ez
From: Eric Duncan
To: ExponentReportGroup
Date: Wed, May 9, 2007 11:53 AM
Subject: Fwd: Results of NEI Review of Exponent Report

The letter and summary report provides NEI's perspective on the Exponent Report that FENOC had requested.

**Effect of Exponent Analysis of
Davis-Besse Reactor Vessel Head Wastage Event
On Industry Inspection Programs**

Figure 2-1
 Davis-Besse Crack Growth Rates Relative to MRP-55 Data

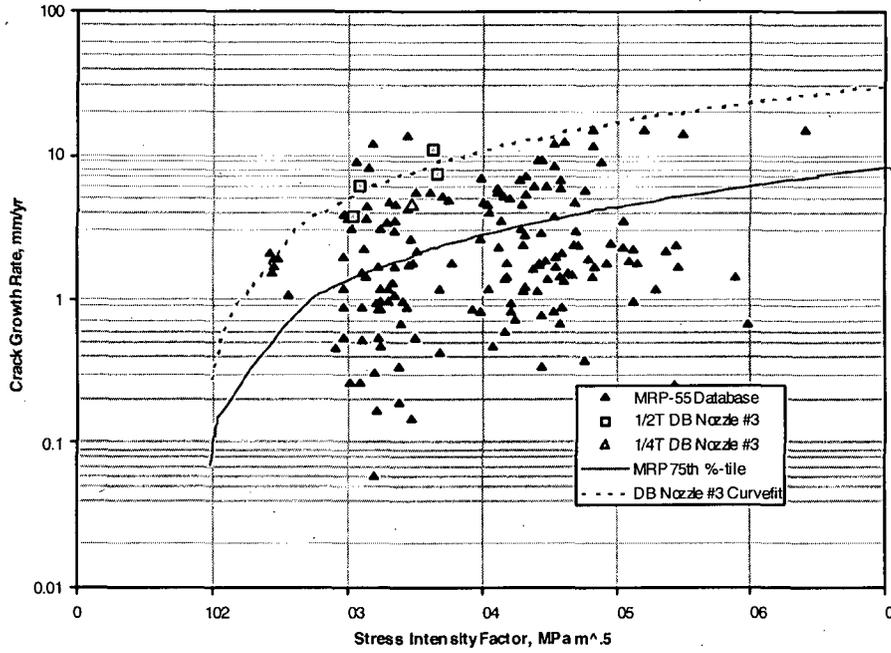
Exponent states that the crack growth rates of the Davis-Besse CRDM nozzle material were up to four times the growth rate of the MRP recommended 75th percentile crack growth curve reported in MRP-55. While this statement is correct, Figure 2-1 from MRP-55 shows that some of the material specimens in the MRP-55 database had crack growth rates even higher than the Davis-Besse material. Therefore, the Davis-Besse material is considered to be within the bounds of previously evaluated materials.

Figure 2-2
Projected Crack Growth and Industry Examination Requirements for a High Temperature Head under Crack Growth Rate Conditions Postulated in Exponent Report

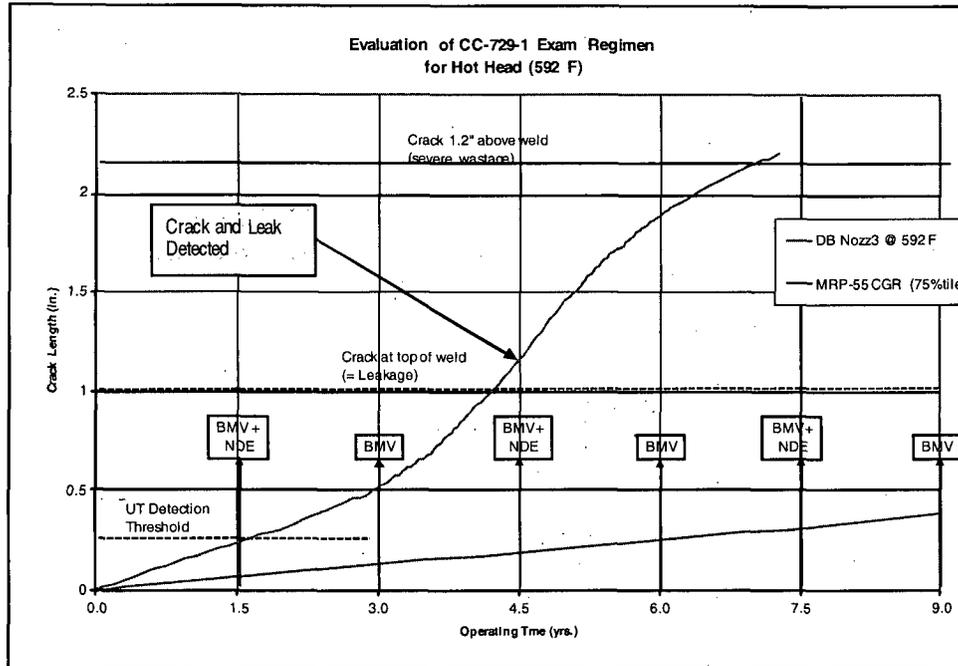
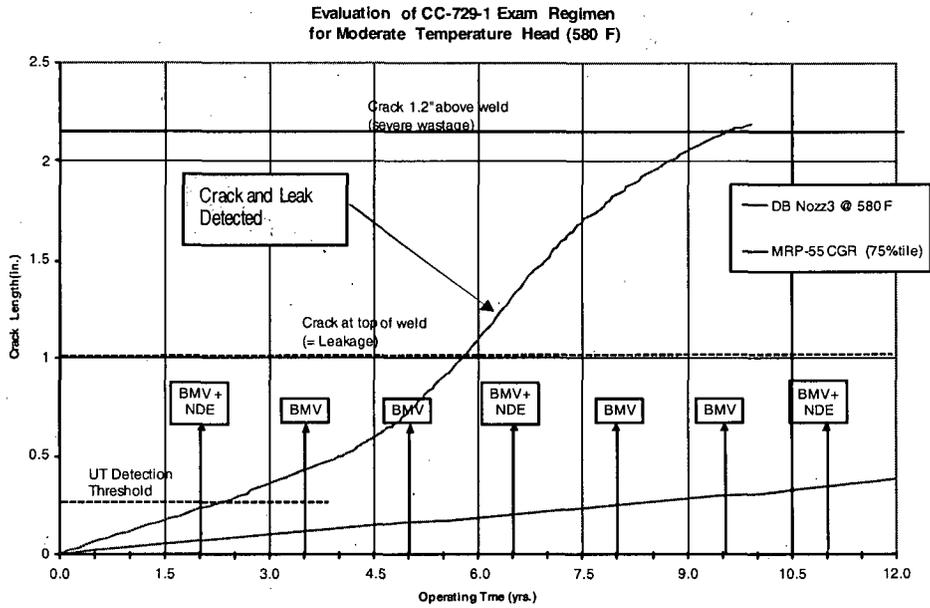
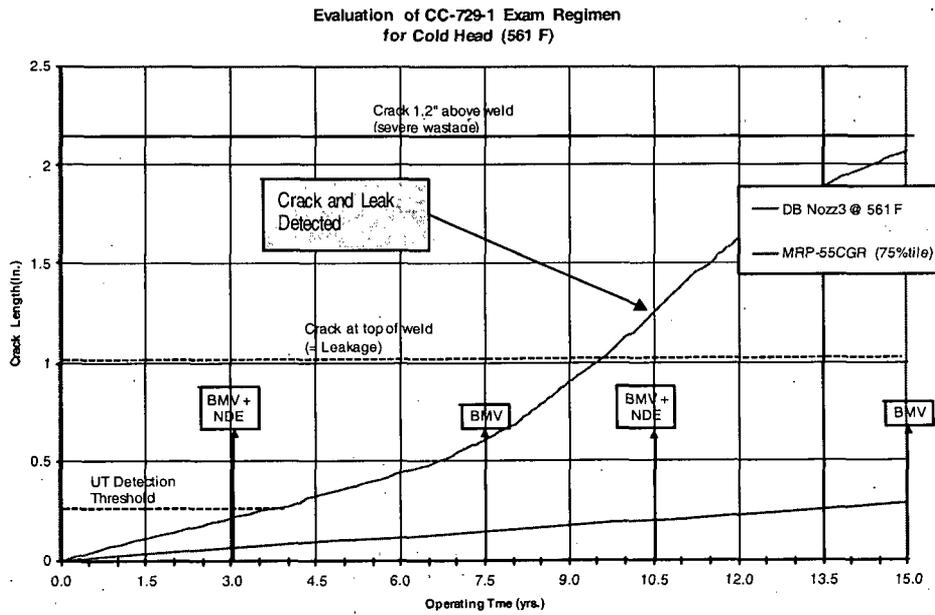
Deterministic predictions of crack growth for the three sample cases, using the crack growth rate curve for Davis-Besse Nozzle 3 referenced in the Exponent report are presented in Figures 2-2, 2-3 and 2-4. In each case, the crack growth rate equation was adjusted to the appropriate head operating temperature in accordance with the Arrhenius equation for crack growth (MRP-55¹). The figures also show the predicted crack growth in accordance with the MRP-55 75th percentile crack growth law for comparison purposes. Several significant crack sizes are shown as horizontal dashed lines on the figures, corresponding to the crack length at which detection by UT would be expected with high confidence (conservatively assumed = 0.25"), the crack length corresponding to the crack at the top of the weld, at which leakage is predicted, and a crack length of 1.2" above the weld, corresponding to the crack length that was discovered at Davis-Besse in 2002. Finally, vertical arrows are plotted on the figures corresponding to the NDE and BMV inspections that would be required at various refueling outages, per Table 2-1 above. Since inspections required per the NRC Order are somewhat more conservative than those required by Code Case N-729-1, only those required per the Code Case are shown on the figures. This produces the most conservative evaluation of the potential effect of the Exponent crack growth rate, since it corresponds to the least amount of inspection that would possibly be performed in the future. Also for conservatism, the initial baseline inspection was assumed to occur at a time when the postulated crack is just below the UT inspection threshold, and would thus be missed.

Figures 2-2 through 2-4 show that for each hypothetical case an NDE + BMV would be performed shortly after the postulated cracks are projected to reach the top of the welds, such that they would be well above the detection threshold of the ultrasonic NDE, and evidence of leakage would likely be detected by the BMV as well. These exams would be performed, and the cracking detected, well before the crack length approached the size predicted to have caused the severe wastage observed in the Davis-Besse head. These results, plus the conservative bounding nature of the deterministic evaluation, were a major factor in the panel's conclusion regarding adequacy of the current industry RPV top head examination program.
